|||||LINCOLN ROAD DISTRICT

**HISTORIC PRESERVATION BOARD
REVISED APPLICATION**

05/14/2024

LINCOLN ROAD DISTRICT IMPROVEMENTS PHASE 3

EUCLID OVAL
REVISED DESIGNS 05/14/2024

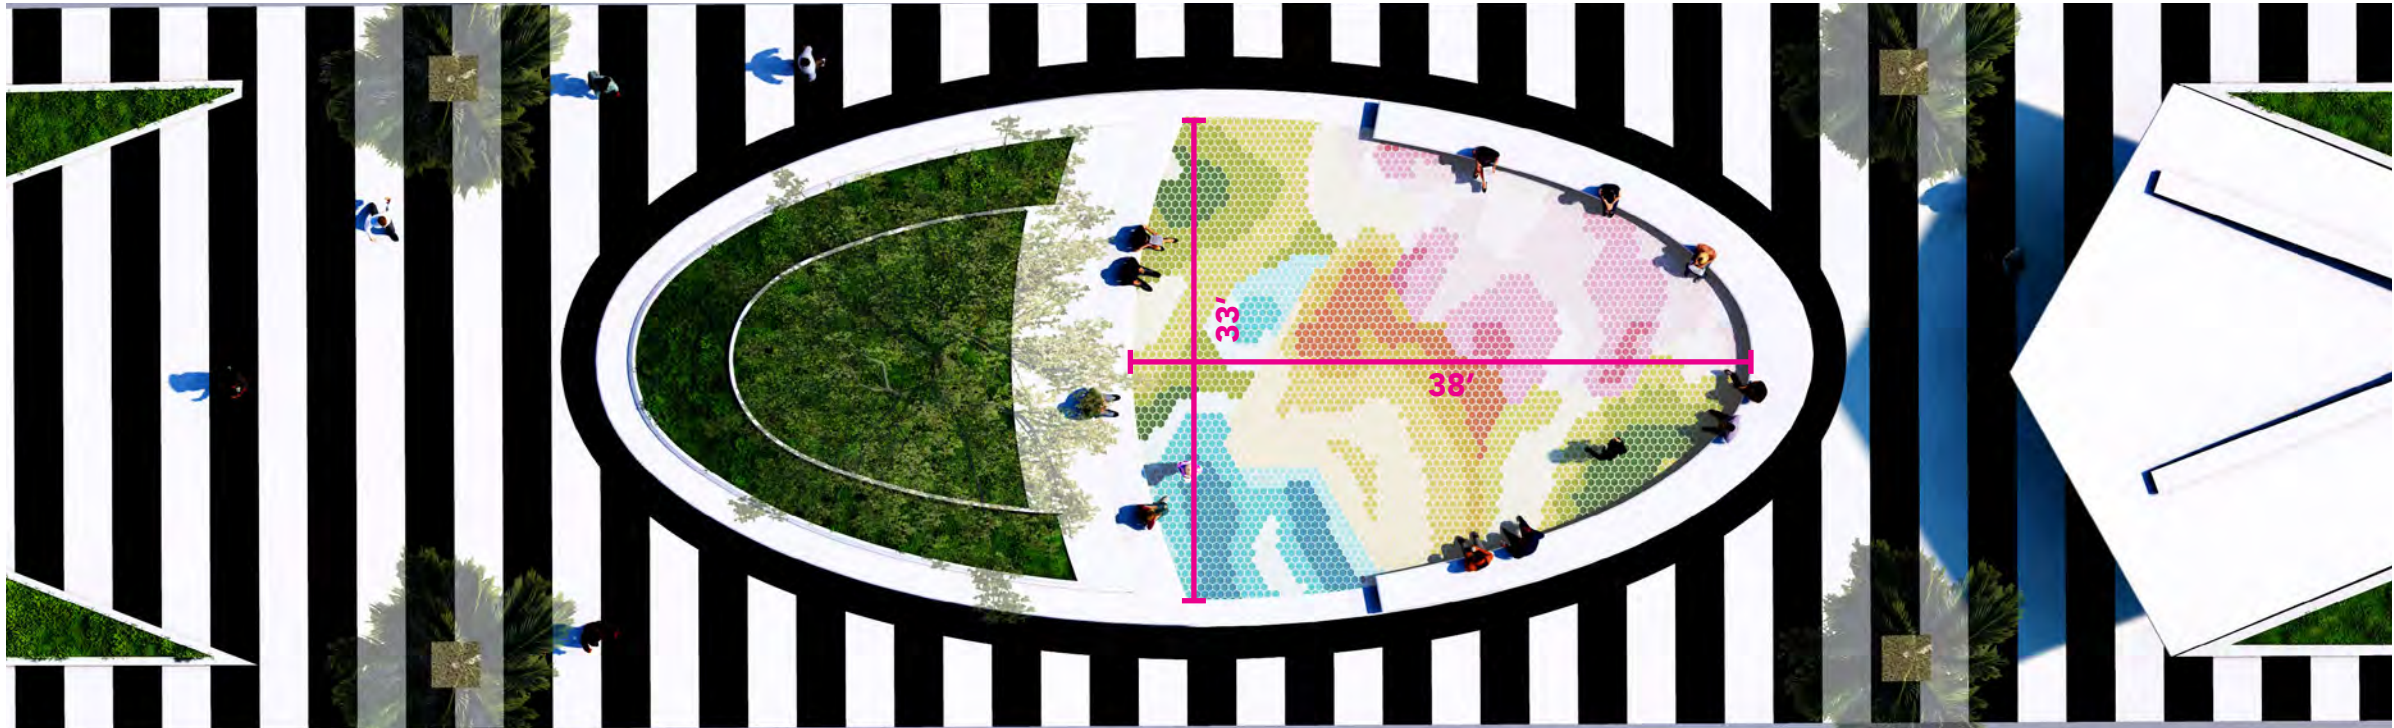
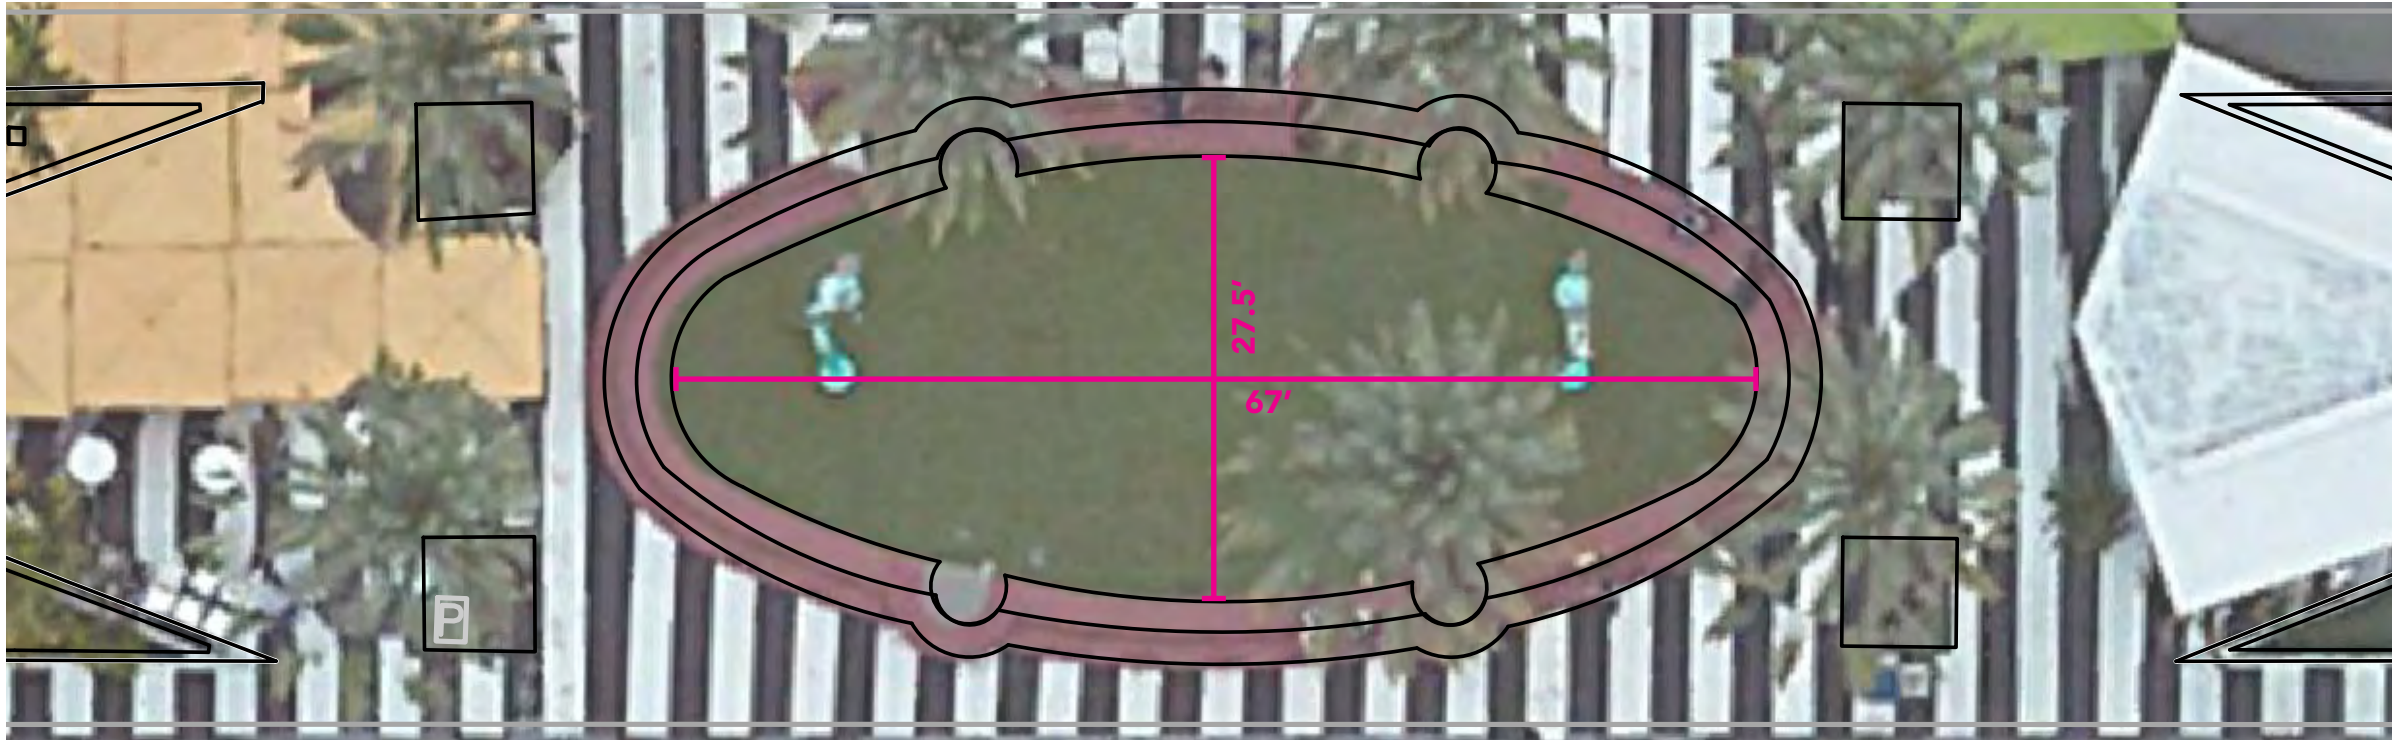
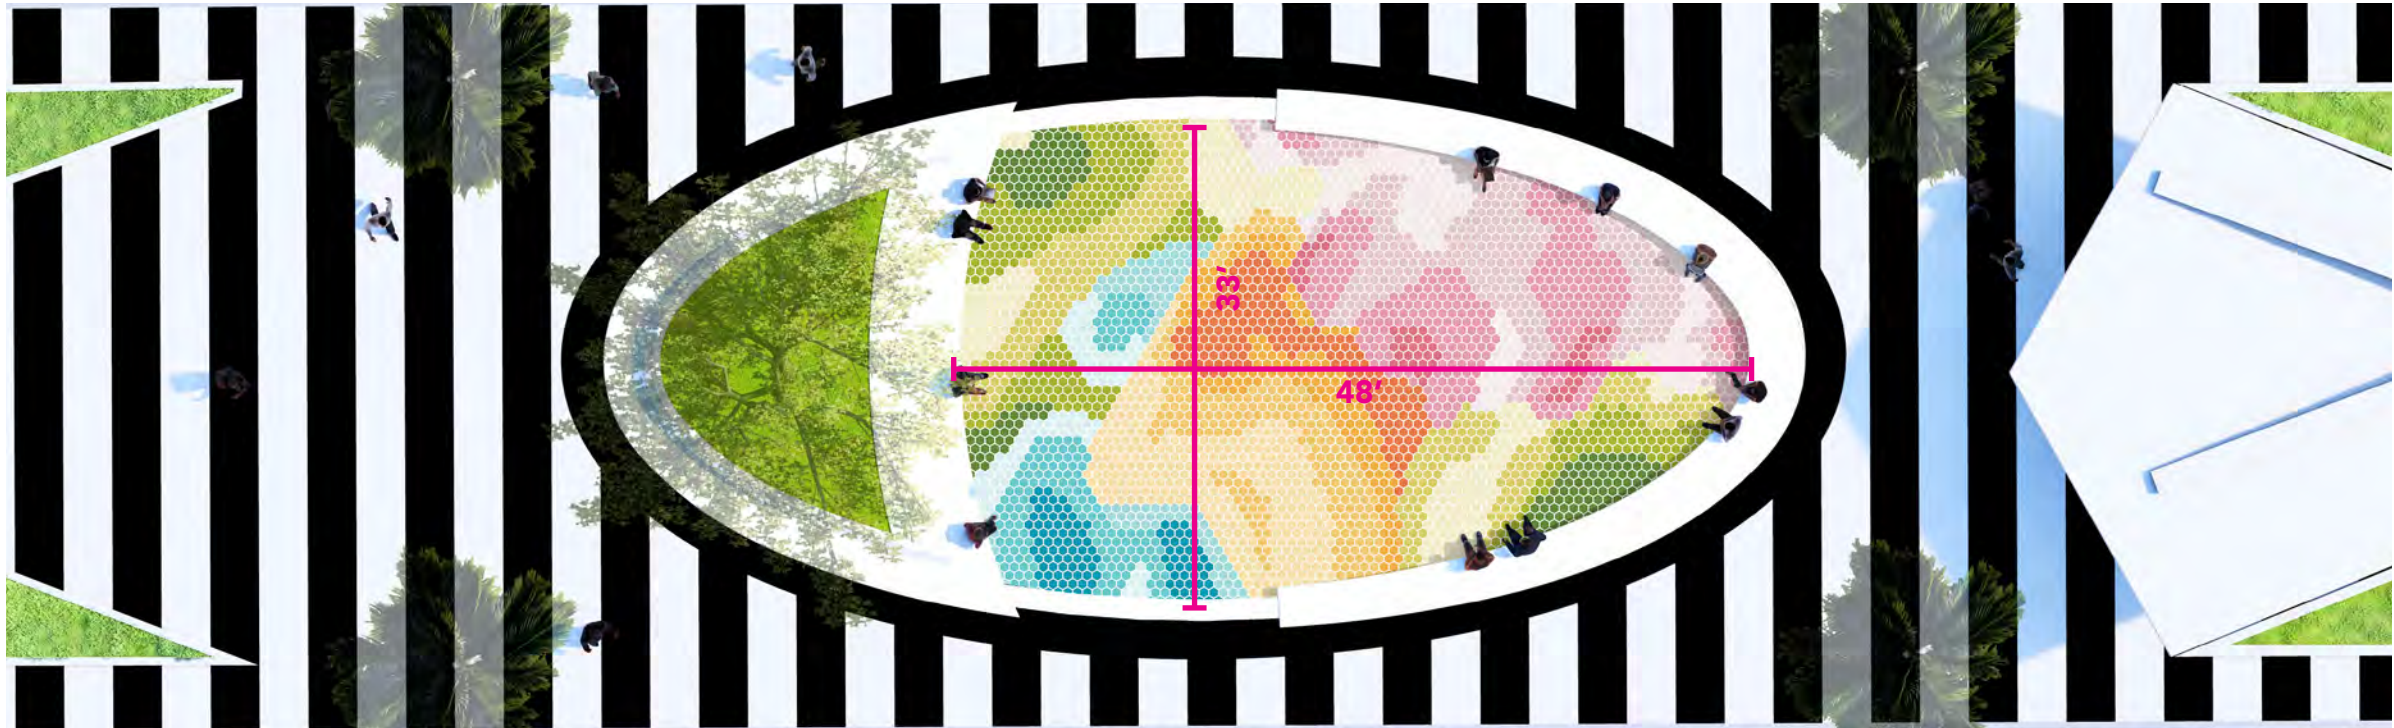
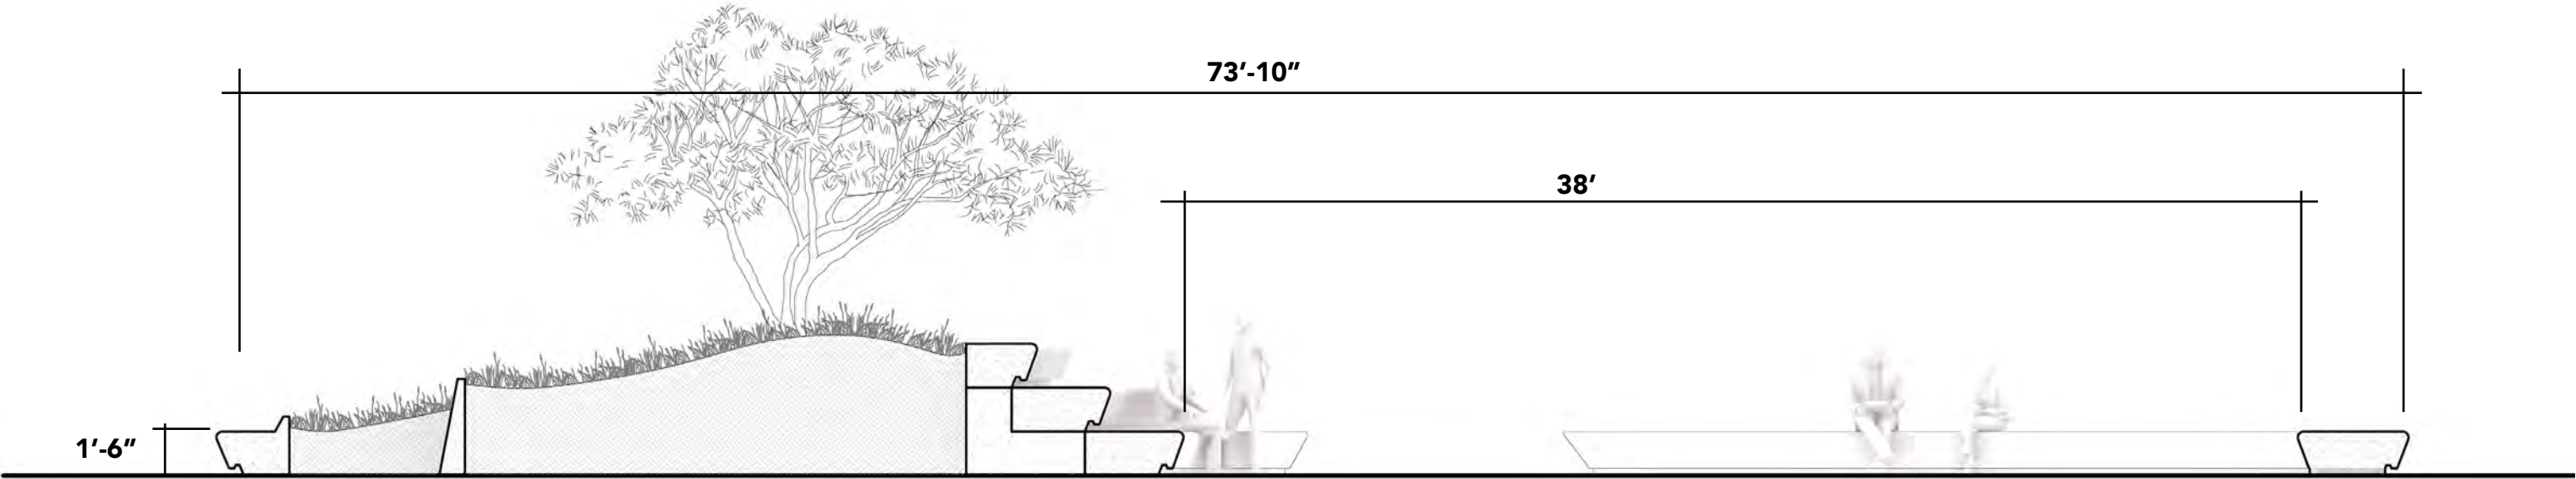
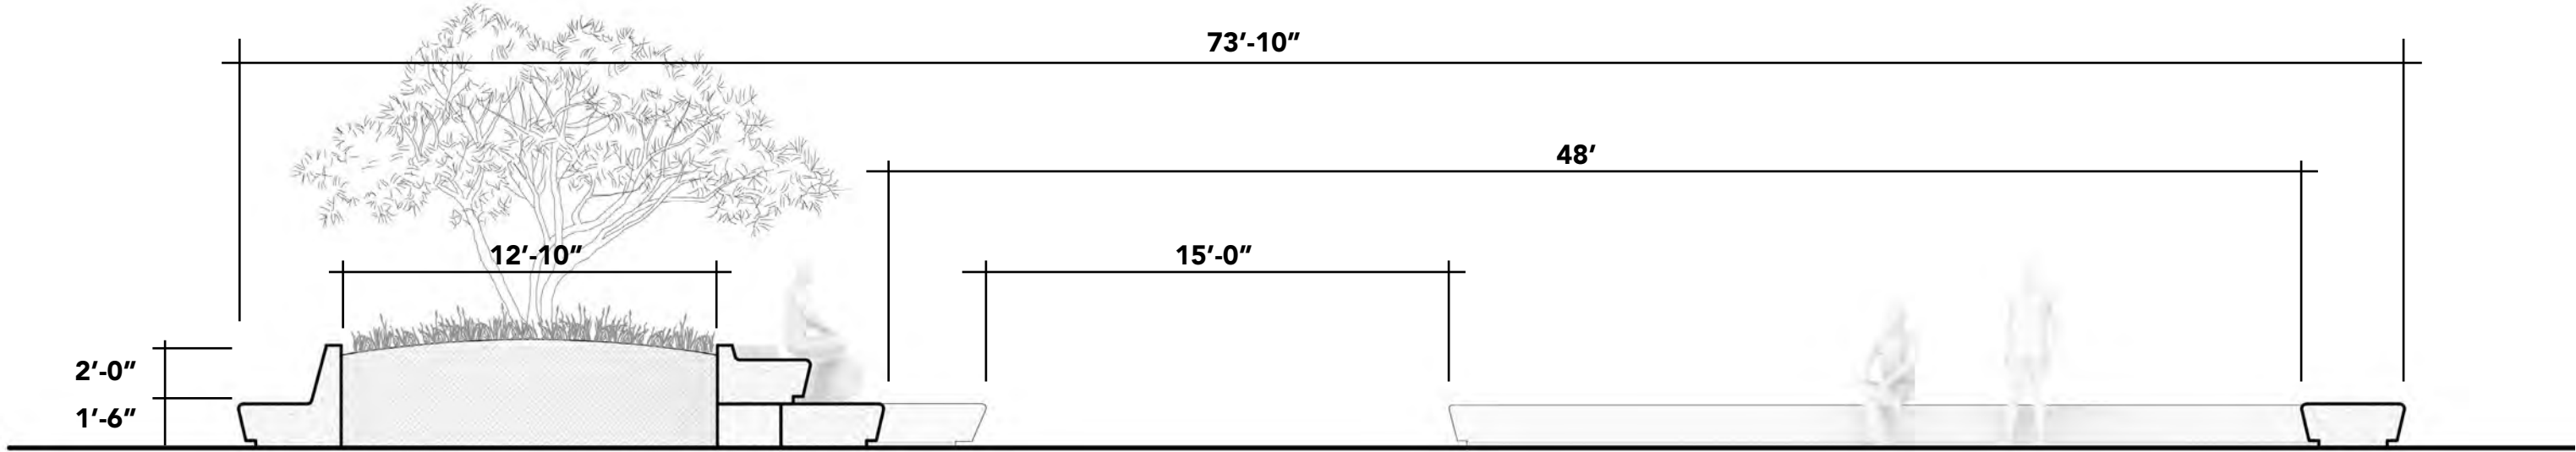
SIZE- REVISIT PROPORTION OF FLEXIBLE AREA AND PLANTER TO ENSURE AREAS CAN FIT CURRENT EVENTS AND INSTALLATION AND PROVIDE COMPARABLE FLEX SPACE

PREVIOUS EUCLID OVAL DESIGN (02/13/2024)
952 SQ FT

REVISED EUCLID OVAL DESIGN (05/14/2024)
1,181 SQ FT

SECTION
PREVIOUS EUCLID OVAL DESIGN (02/13/2024)

SECTION
REVISED EUCLID OVAL DESIGN (05/14/2024)
